## SARASOTA COUNTY

RE: Central County Solid Waste Disposal Complex  
Permit Number 130542-007-SO/01  
Response to FDEP Inspection – June 2, 2010

Photo #1

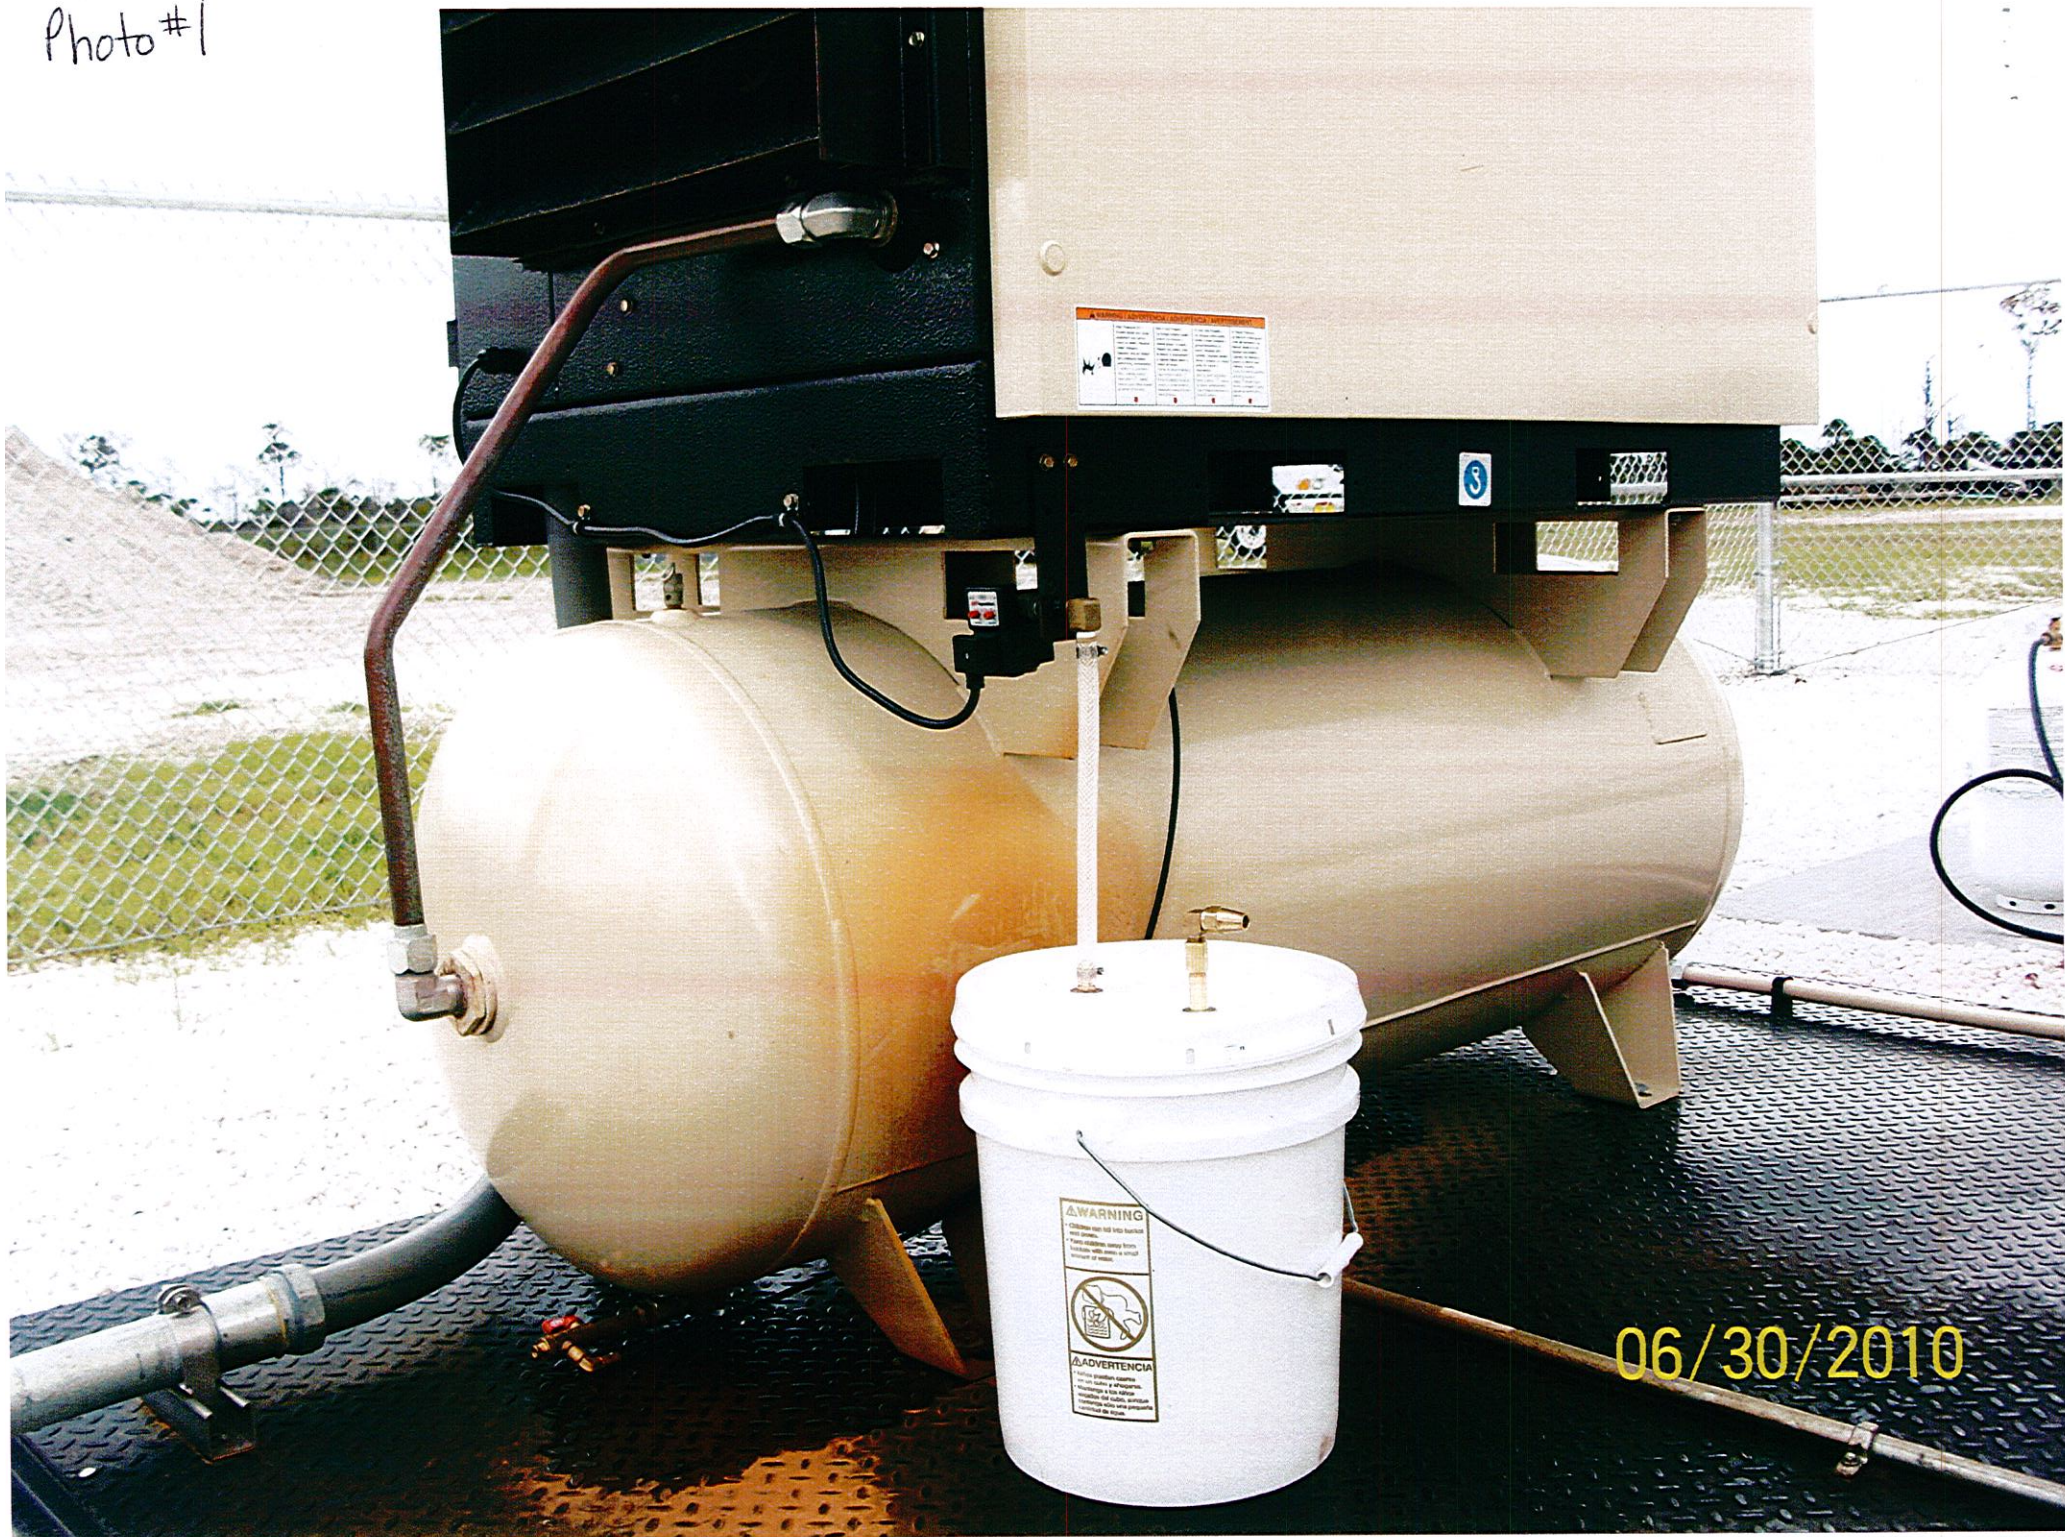
***Comments Section – Compressor blow-off was observed around the base of the air compressor unit. Operator indicated that County intends to manage the liquids to prevent them from discharging on the ground around the compressor. Please provide addition information.***

Compressor blow-off water is captured into a collection container and emptied on an as needed basis into the leachate collection system for treatment at a permitted wastewater treatment facility (see photo #1).
